Subject: PG&E: East Ravine and TCS Work Plan Addendum

Addendum to the Revised Work Plan for East Ravine Groundwater Investigation, PG&E Topock Compressor Station, Needles, California

Re: FMIT comments on PG&E's August 27, 2010, document titled "Addendum to the Revised Work Plan for East Ravine Groundwater Investigation, PG&E Topock Compressor Station, Needles, California"

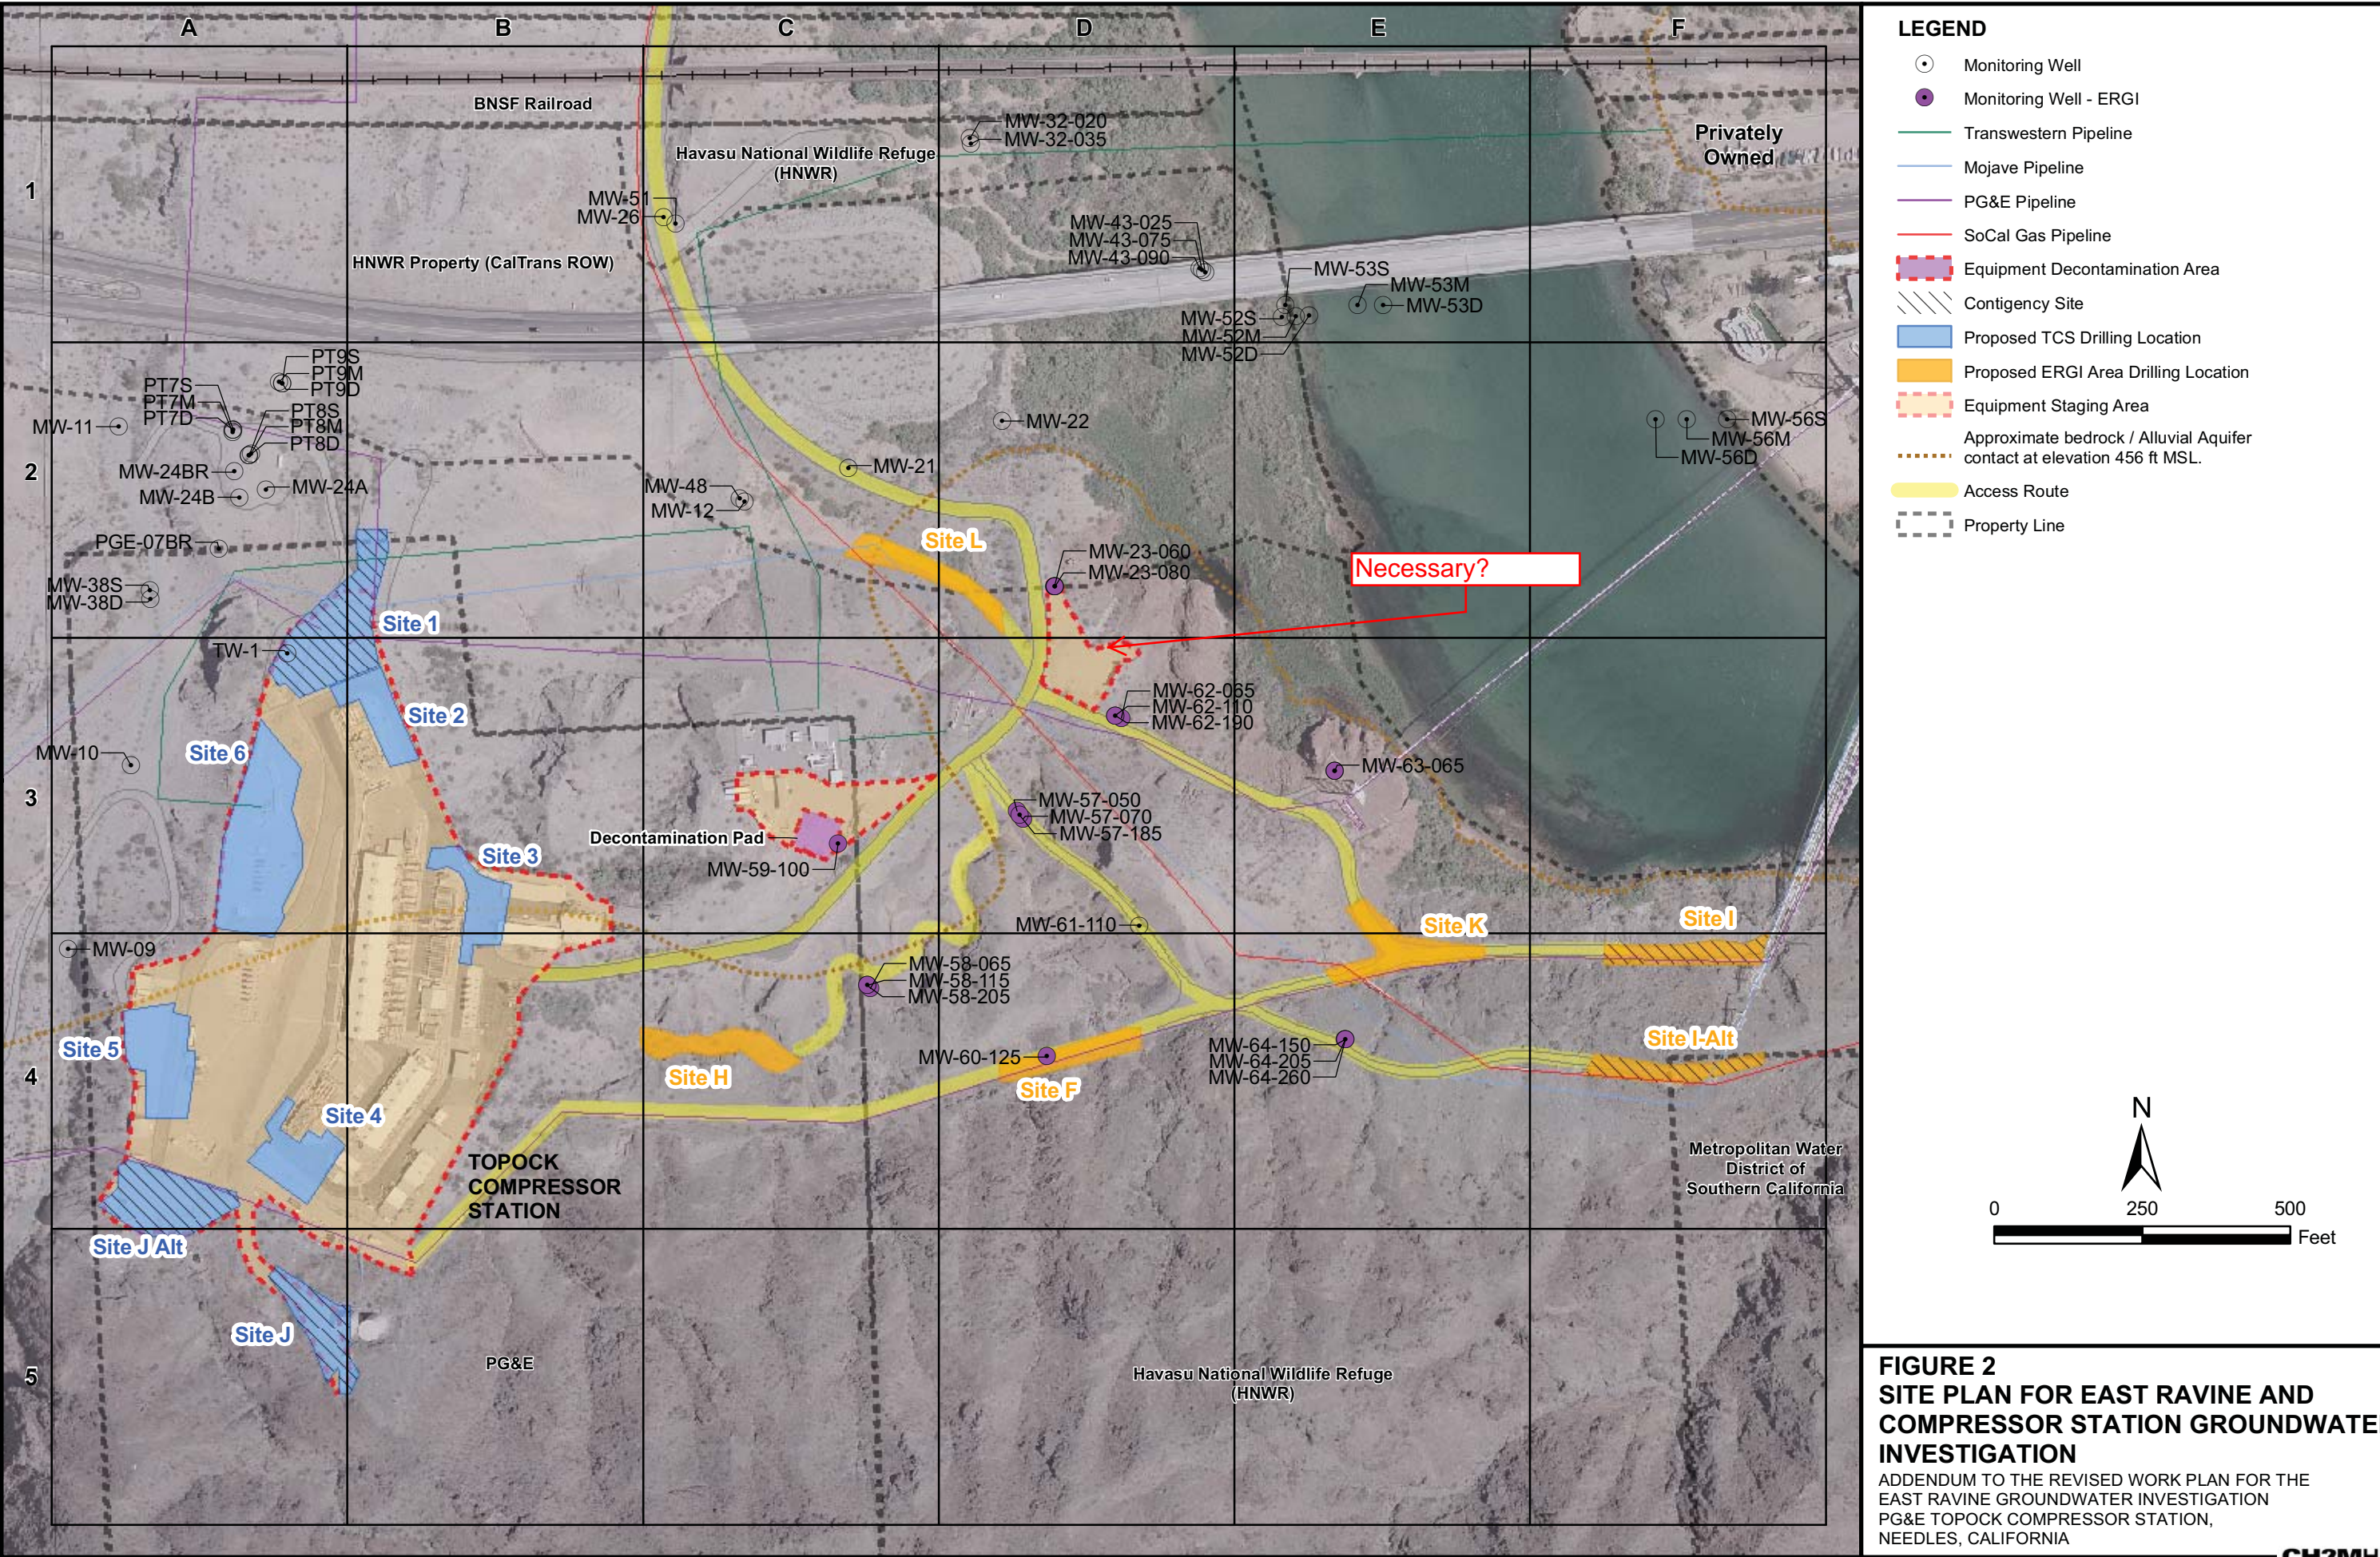
Section 2.7 (Site Restoration Activities) contains errors, is vague, and provides no mitigation or restoration standards. For example, it states that location "I-Alt" is on the Havasu National Wildlife Refuge property; however, Figure 2 shows it located, at least in part, on Metropolitan Water District (MWD) property. Has MWD signed off on this use of their land? This section also delays restoration discussions and requirements until "after well installation." Criteria for site restoration must be developed, reviewed, and approved as part of the work plan. The Tribe expects to participate in these discussions during work plan preparation and prior to its approval.

The Tribe has also questioned why such large areas are called out for each of the primary sites and contingency sites as indicated on Figure 2. It would seem that the actual drilling and construction activities would only disturb much smaller areas. While these large delineations were possibly intended to represent general locations areas within which much smaller disturbances would occur, this is not explained in the workplan.

FIGURE 3
SCHEMATIC OF
NESTED WELL CONSTRUCTION
 ADDENDUM TO THE REVISED WORK PLAN
 FOR EAST RAVINE GROUNDWATER INVESTIGATION
 PG&E TOPOCK COMPRESSOR STATION
 NEEDLES, CALIFORNIA

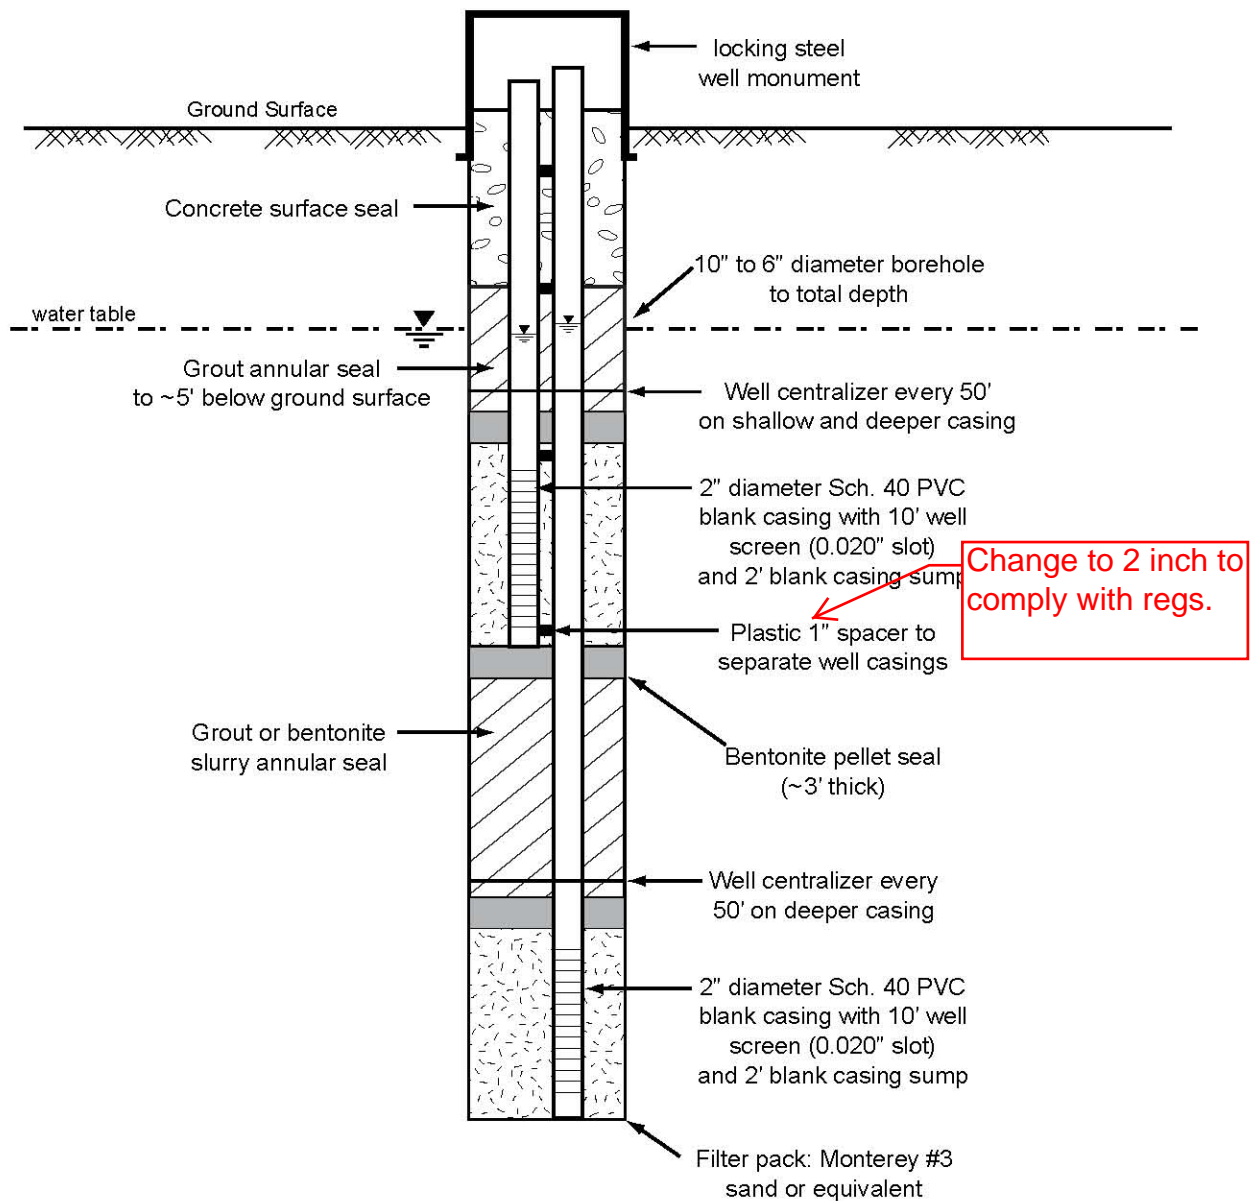
2. Footnote 1 of Table 1 attached to our July 28, 2010 direction letter specified: "Site K: At a minimum, a shallow water table well shall be constructed as per Figure 5 (Shallow Zone Monitoring Well) of the July 11, 2008 Work Plan."

FIGURE 4
 Estimated Implementation Schedule
 Addendum to the Revised Work Plan for
 East Ravine Groundwater
 PG&E Topock Compressor Station
 Needles, California

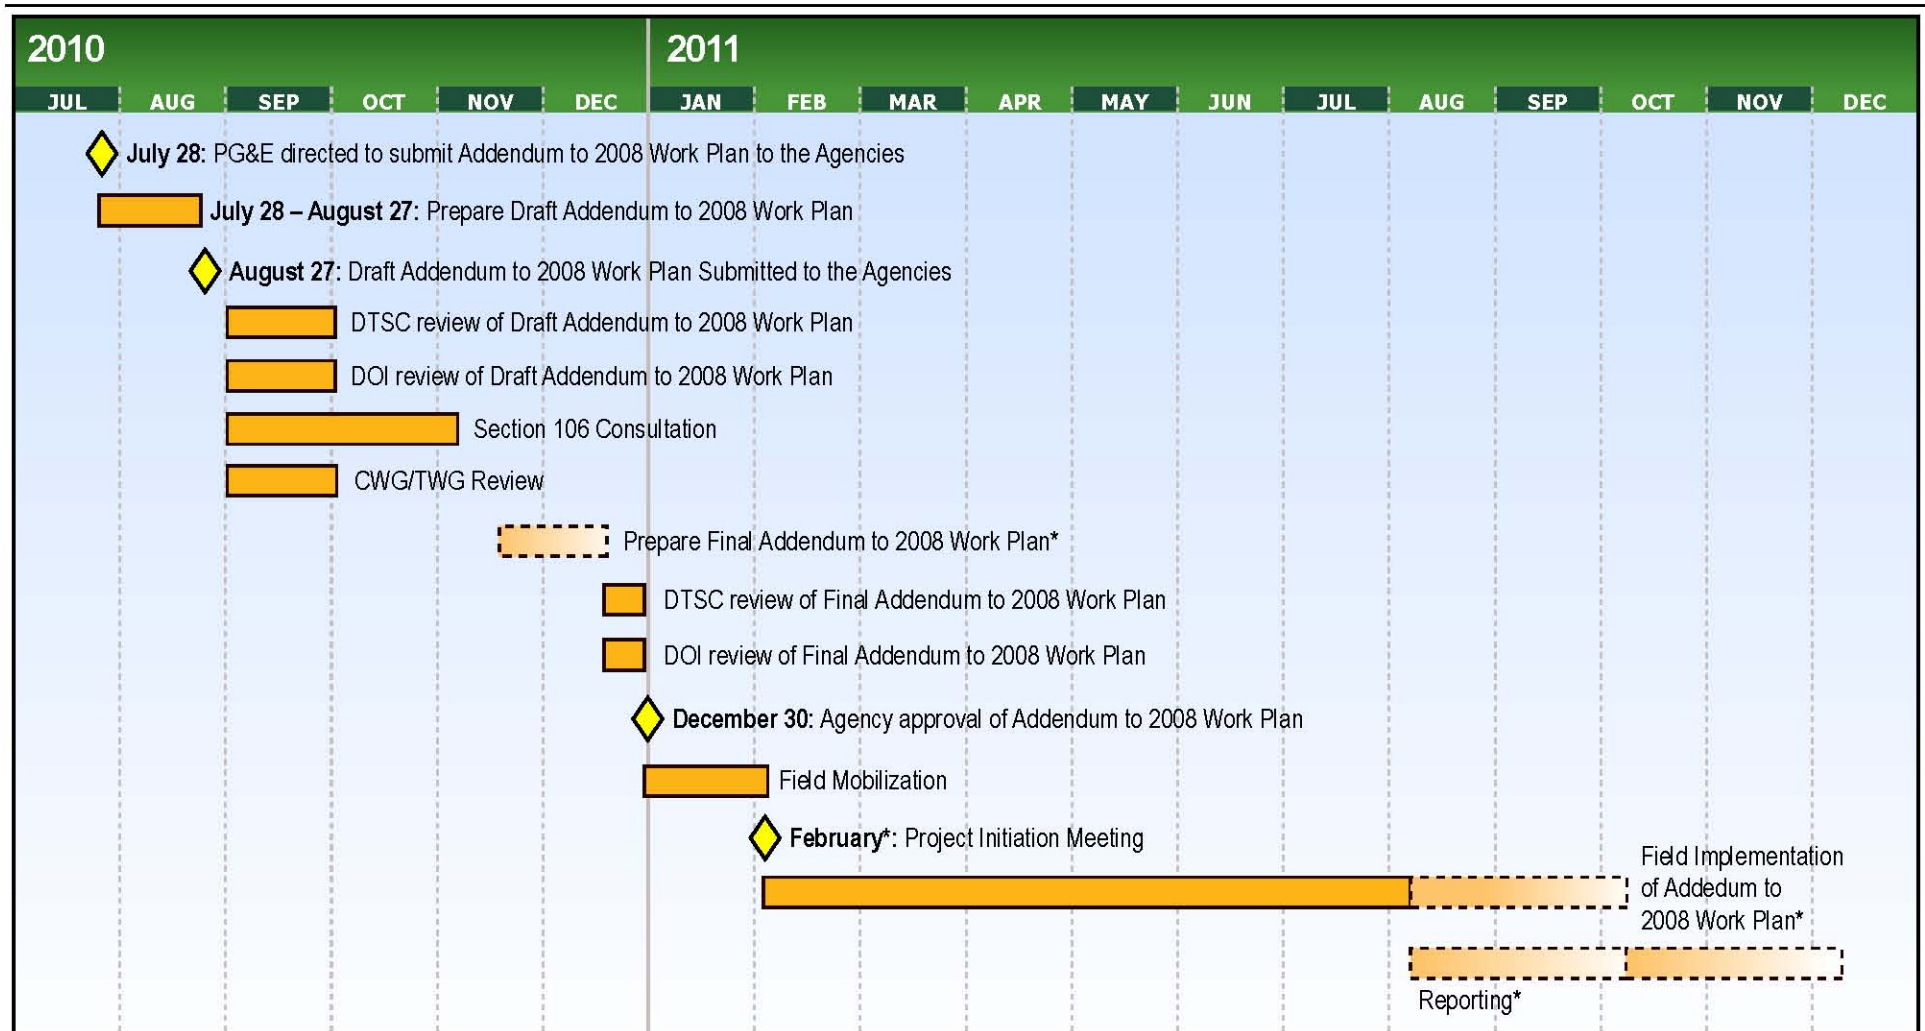
A related matter is the block for Section 106 consultation on the associated schedule (Figure 4). Do the agencies believe they have started this consultation? How do the agencies propose to finish it? Has a determination of adverse effect been made? Have they actually initiated consultation? Has anybody started negotiating toward a memorandum of agreement? These, again, are matters of major concern to the Tribe at this juncture and moving forward.
